T-SB-0205-11 Rev2 December 23, 2011

# MIL "ON" DTC P3190, P3191 and/or P0A0F

| YEAR(S)     | MODEL(S) | ADDITIONAL INFORMATION |
|-------------|----------|------------------------|
| 2010 – 2011 | Prius    |                        |

Figure 1. Location of Authorized Modifications Label on 2010 and 2011 Prius

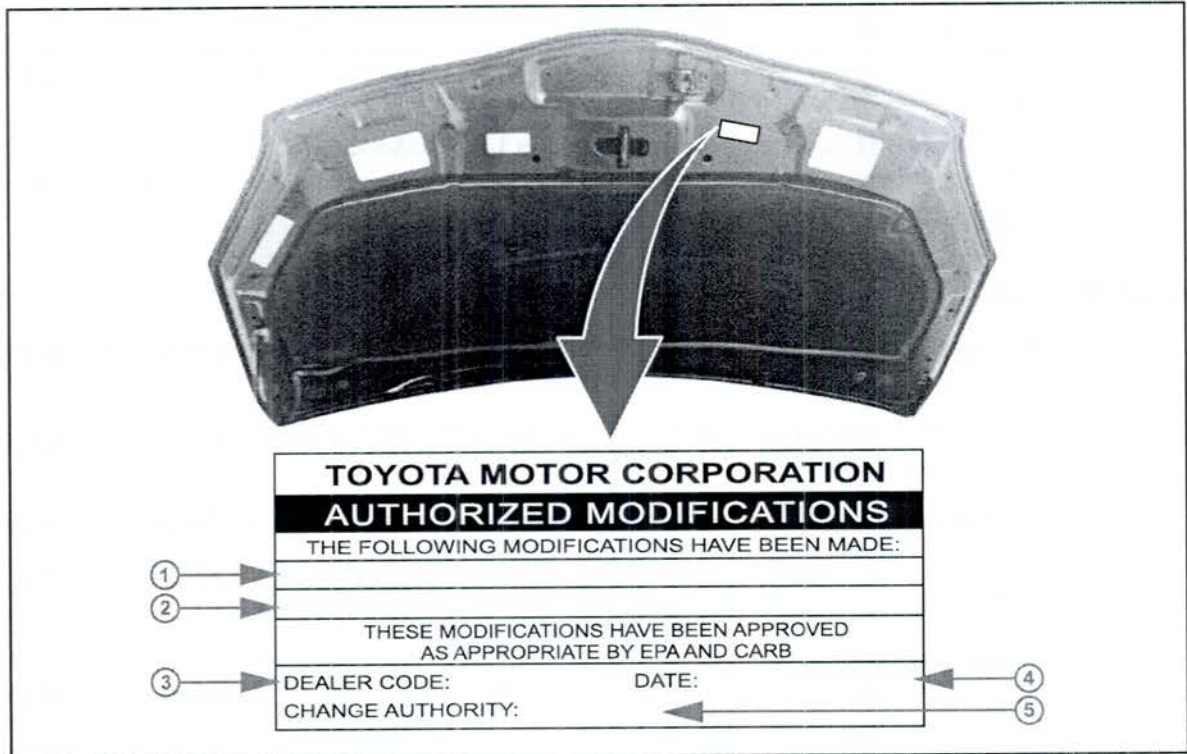
4. Install the Authorized Modifications Label.
  - A. Using a permanent marker, enter the following information on the label:
    - ECM part number [*Refer to the **Parts Information** section for the **CURRENT PART NUMBER***]
    - Calibration ID(s) [*Refer to the **Calibration Identification Chart** for the **NEW CALIBRATION ID***]
    - Dealer Code
    - Repair Date
    - Change Authority [***This SB number***]
  - B. Affix the Authorized Modifications Label to the vehicle at the location shown in Figure 1. The Authorized Modifications Label is available through the MDC, P/N 00451-00001-LBL.
5. Test drive the vehicle to confirm proper vehicle operation.
